ITEM #: 900.620 SHEET 5 OF 5

Galvanized 2-Rail Box Beam Guardrail Approach Section

EM14-202, CHICKEN FARM ROAD (T.H.16) CLASS 3 LOCAL ROAD, BRIDGE NO : 36
 PROJECT: 618 CORINTH BRO 1447(29), TOWN OF CORINTH, ORANGE COUNTY, VT

WW 1

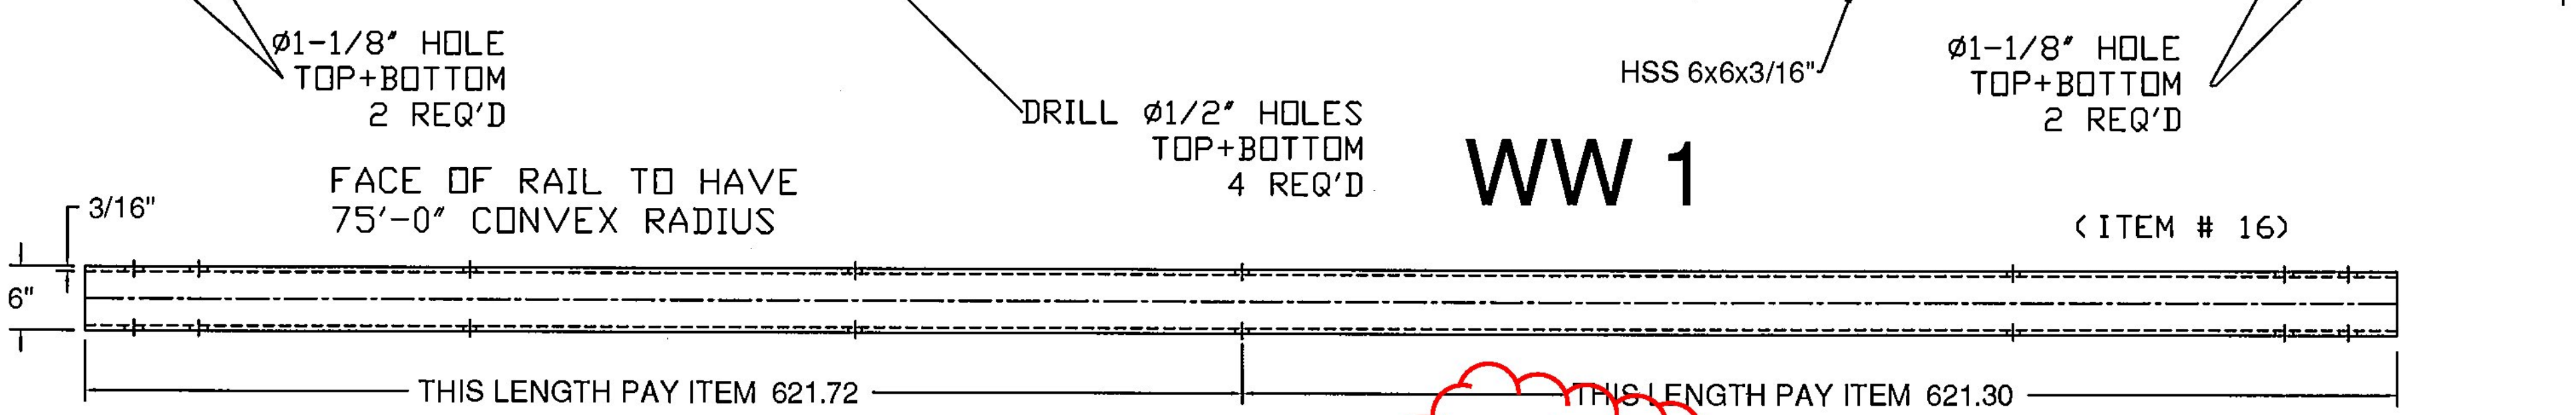
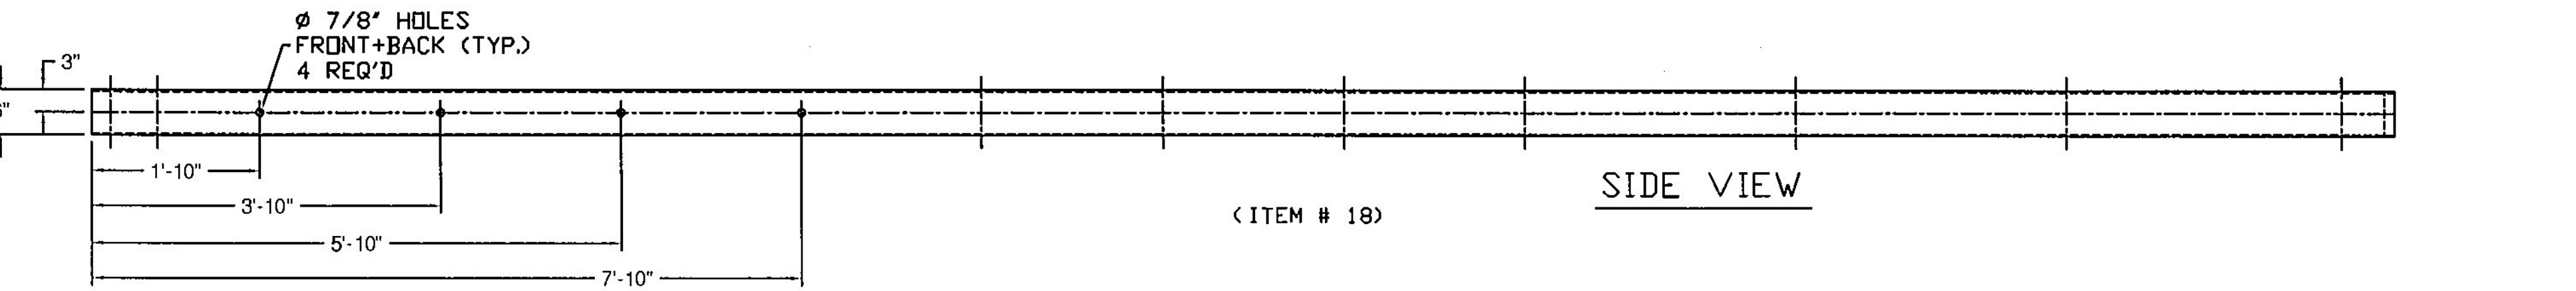
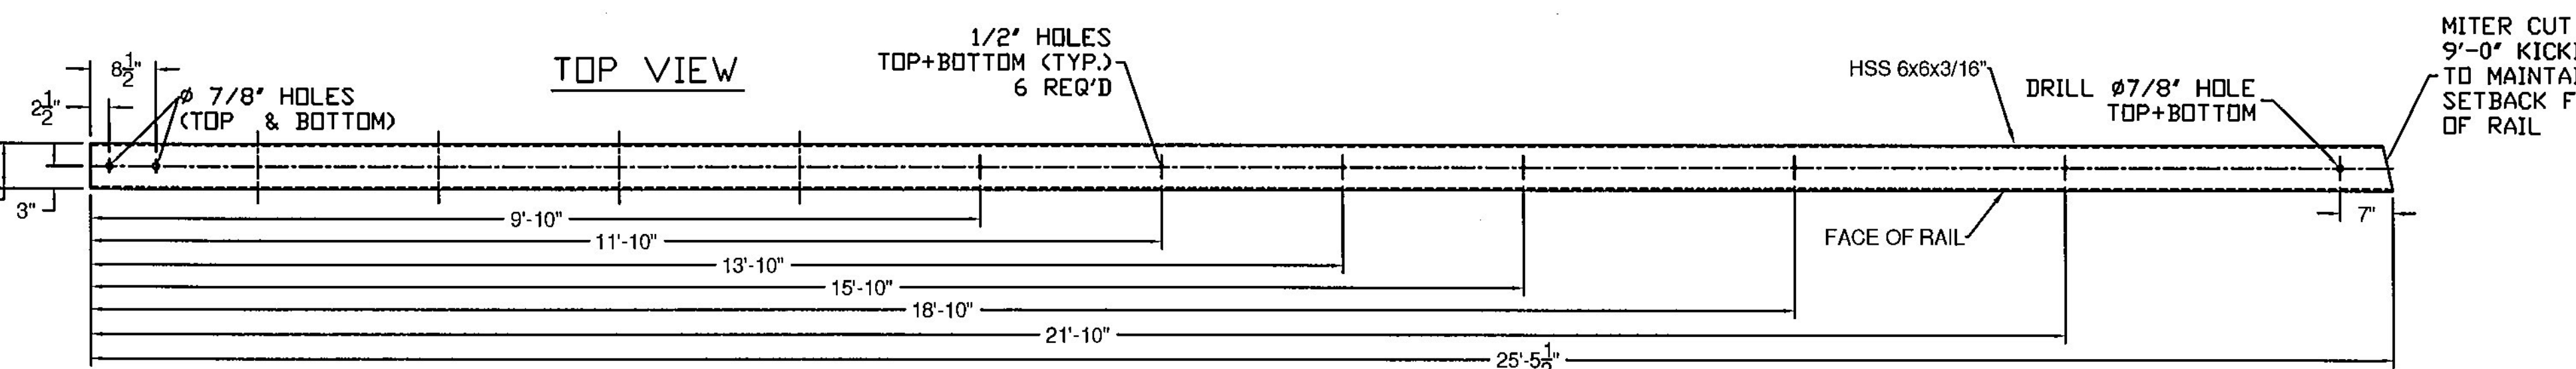
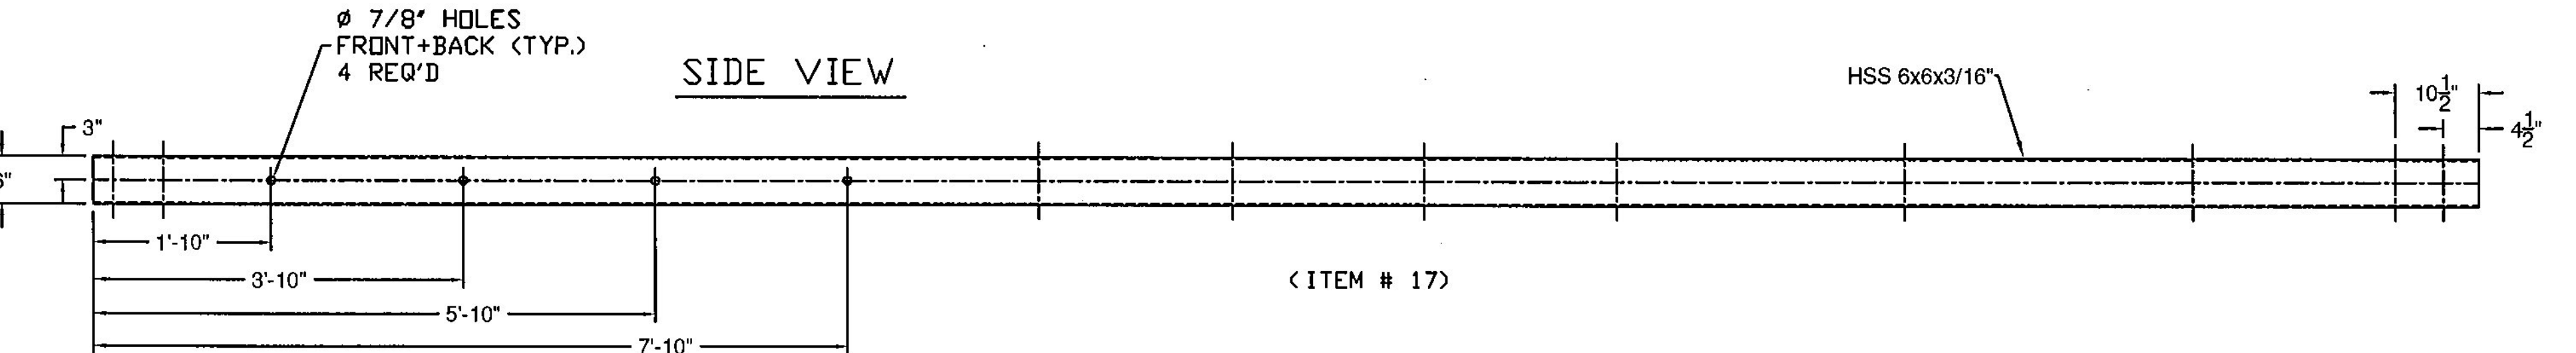
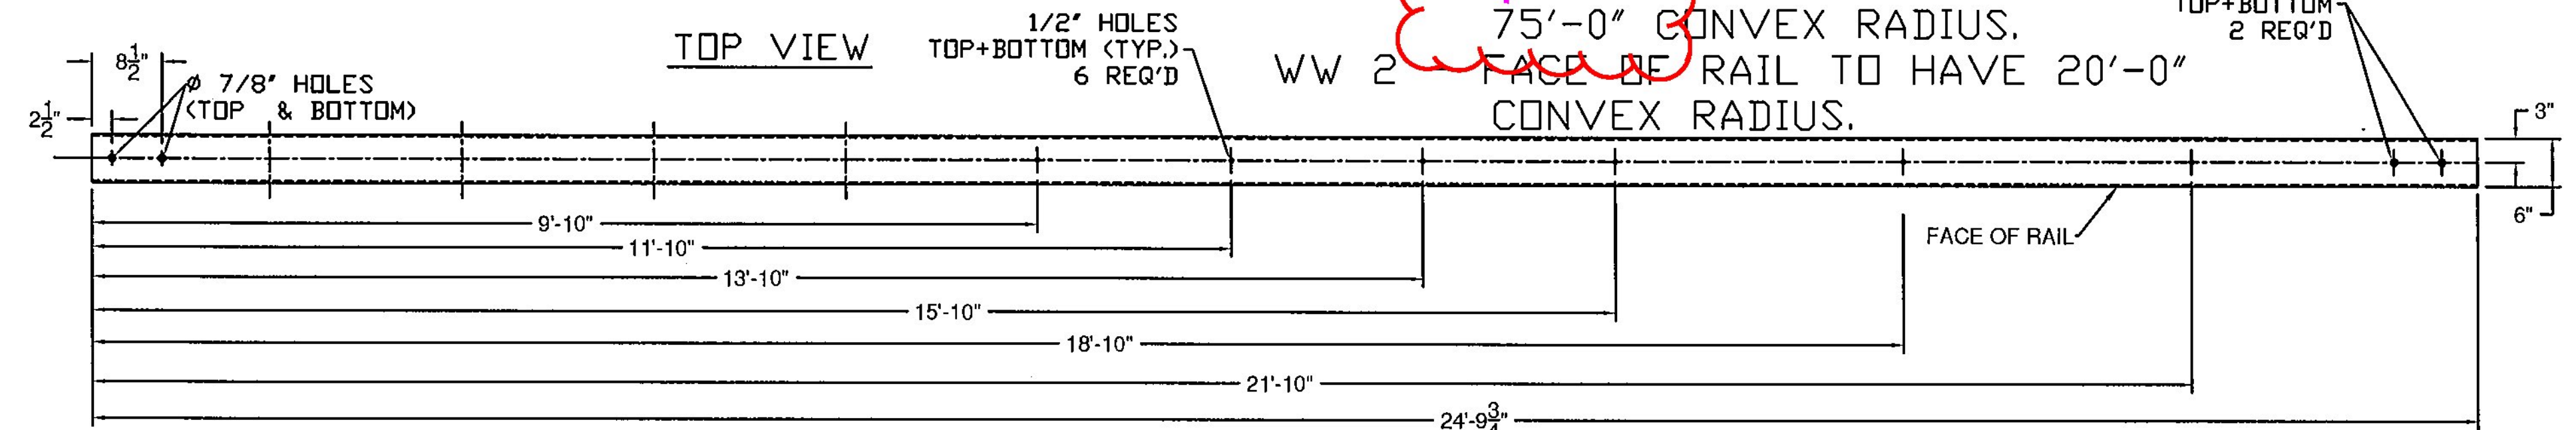
WW 1 - FACE OF RAIL TO HAVE 75'-0" CONVEX RADIUS.
 WW 2 - FACE OF RAIL TO HAVE 20'-0" CONVEX RADIUS.
